Modification of a Previously Approved Contributing Zone Plan Checklist

Re: Approval of a Contributing Zone Plan (CZP)
Sweetwater Lot 3B; Located at 16620 Sweetwater Village Dr.; ETJ of Bee Cave, Travis
County, Texas
Edwards Aquifer Protection Program ID: 11003504, Regulated Entity No. RN111686408

SITE DEVELOPMENT PERMIT PLANS SWEETWATER LOT 3B

DRAWING TITLE:
SITE PLAN & DIMENSIONS

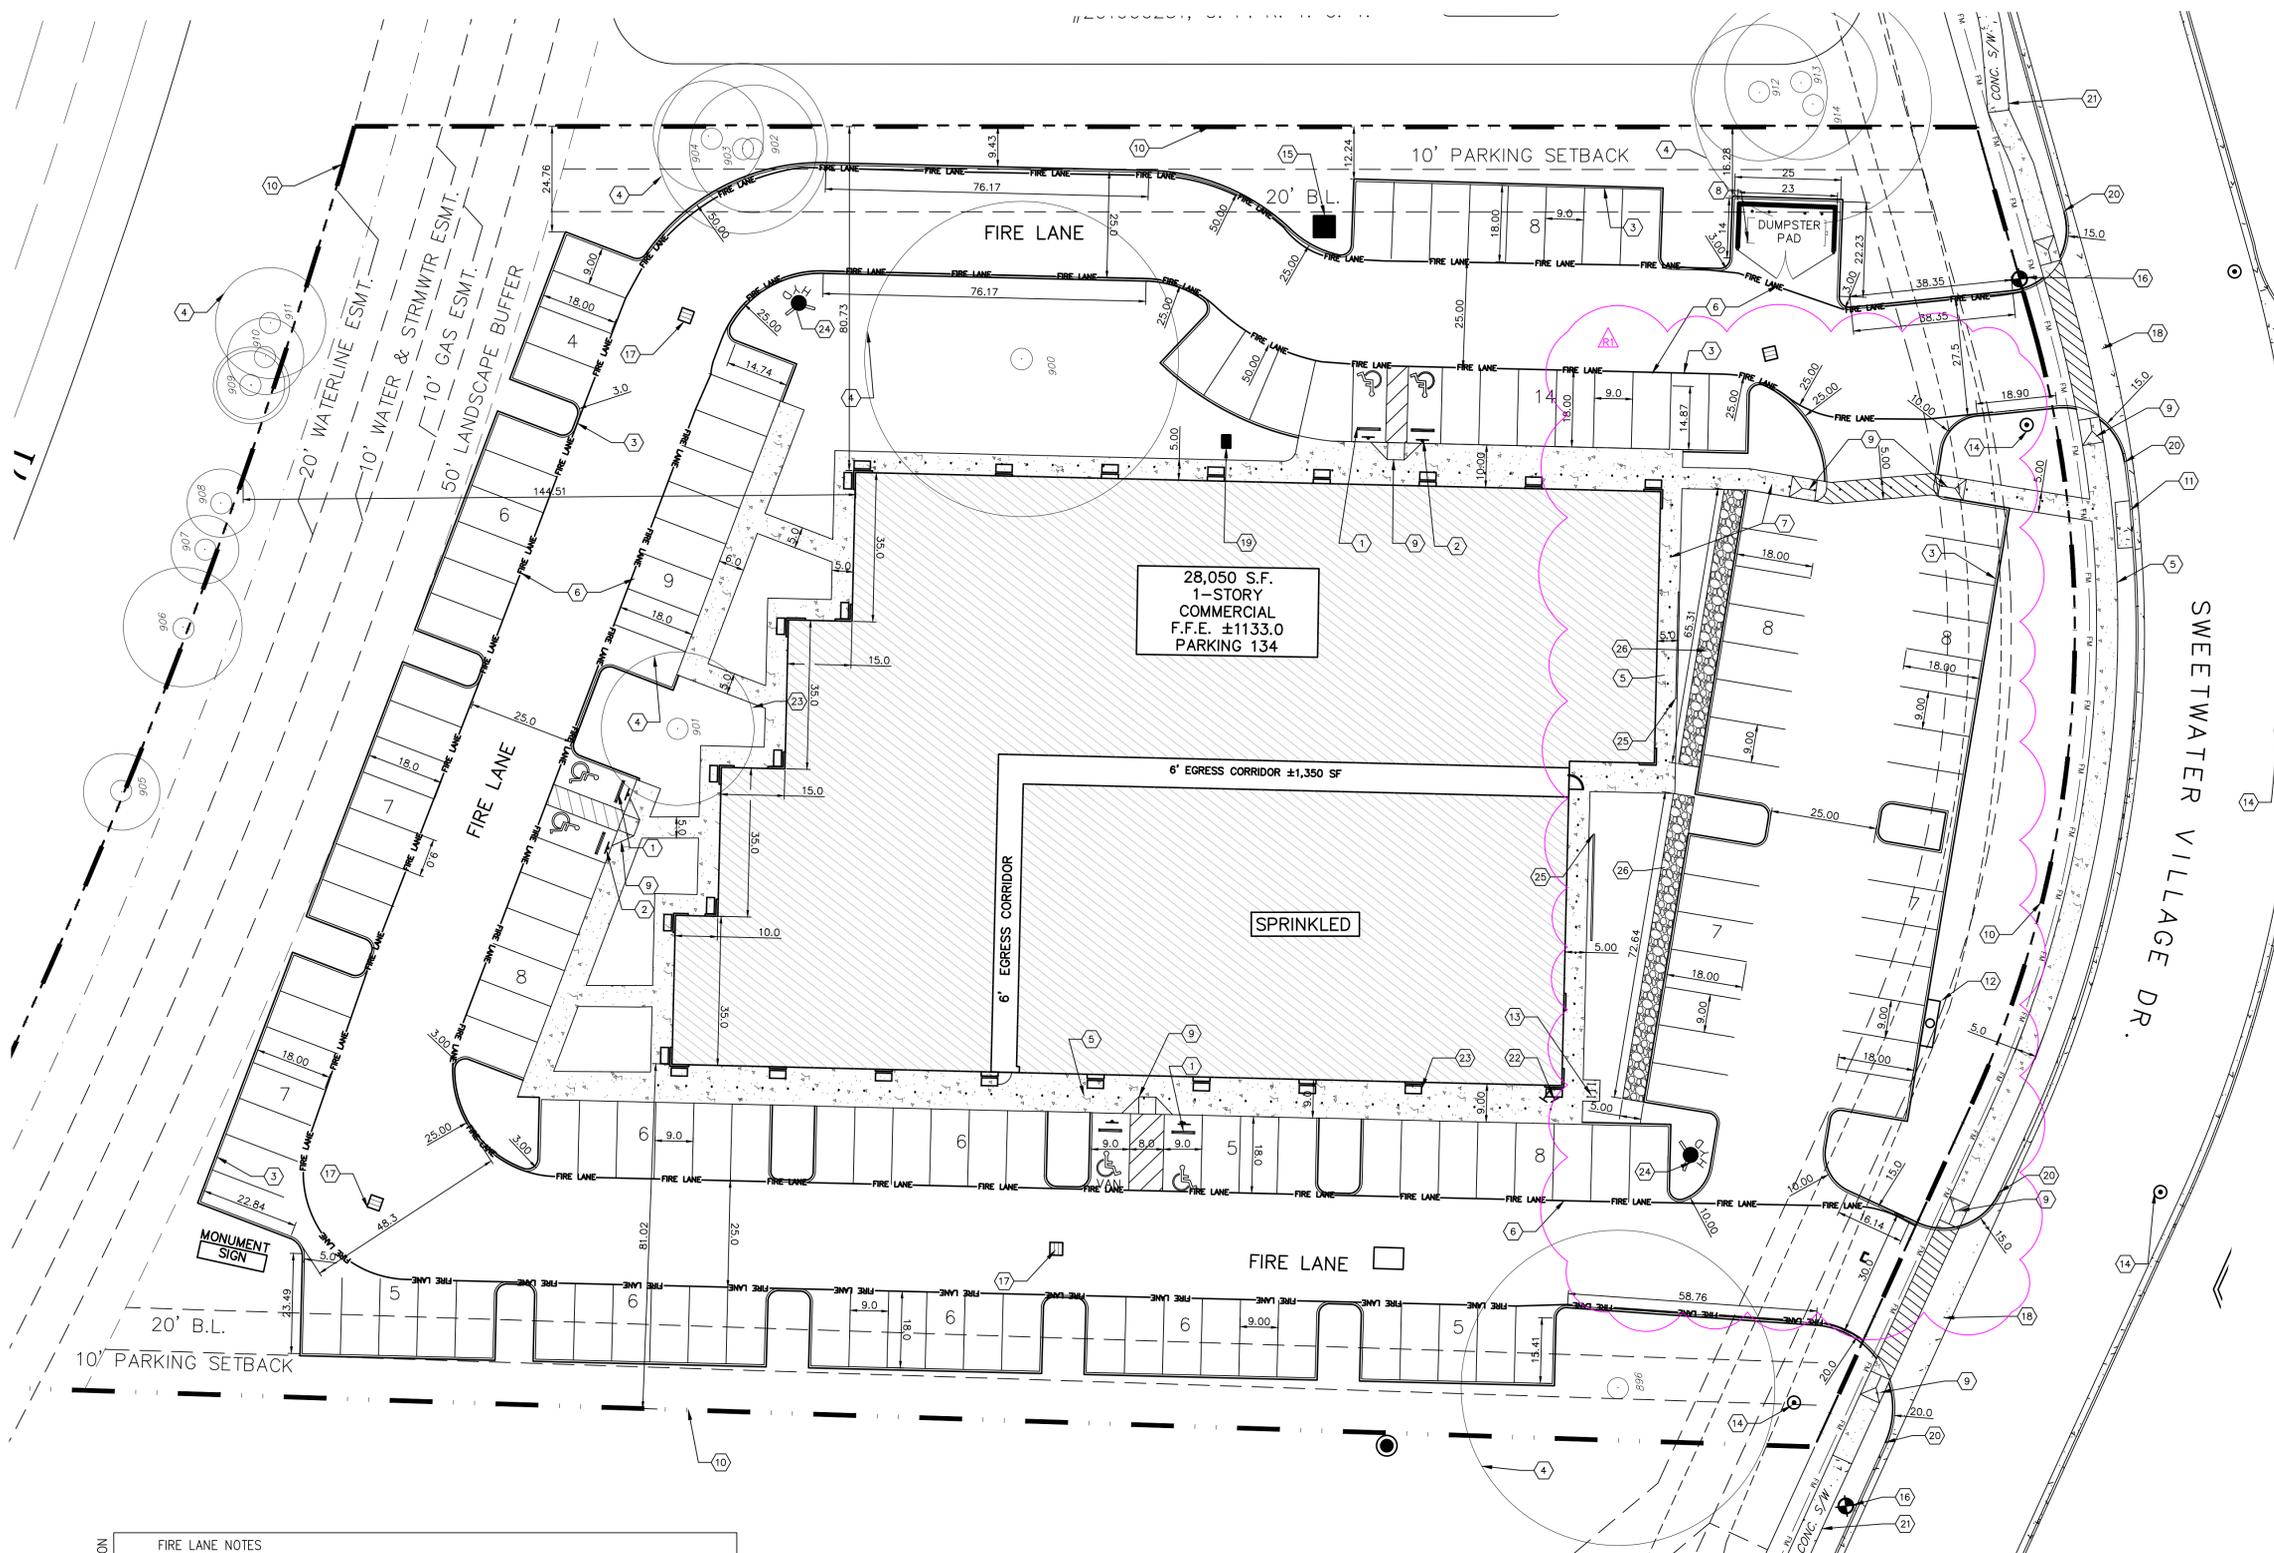
1. **Building Height:** The structure has been revised from a 2-story to a 1-story building.
2. **Square Footage:** The total building area has increased slightly from 26,810 square feet to 28,050 square feet.

3. **Impervious Cover:** The impervious cover has increased by 3%. However, the project remains well within the capacity of the existing detention pond, which was designed for 70% impervious cover. The current design provides only 65.16%. This change has been reviewed and approved by the Sweetwater development team.

6. **Parking:** Only one additional parking space has been added beyond what was previously approved.
7. **Tree Protection:** All existing trees are being preserved and protected in accordance with county and development guidelines.

GRASS	46,870 SF	1.076 AC.
BUILDING	28,050 SF	0.644 AC.
CONCRETE	59,759 SF	1.371 AC.
TOTAL	134,687 SF	3.092 AC.
TOTAL IMPERVIOUS COVER		65.16%
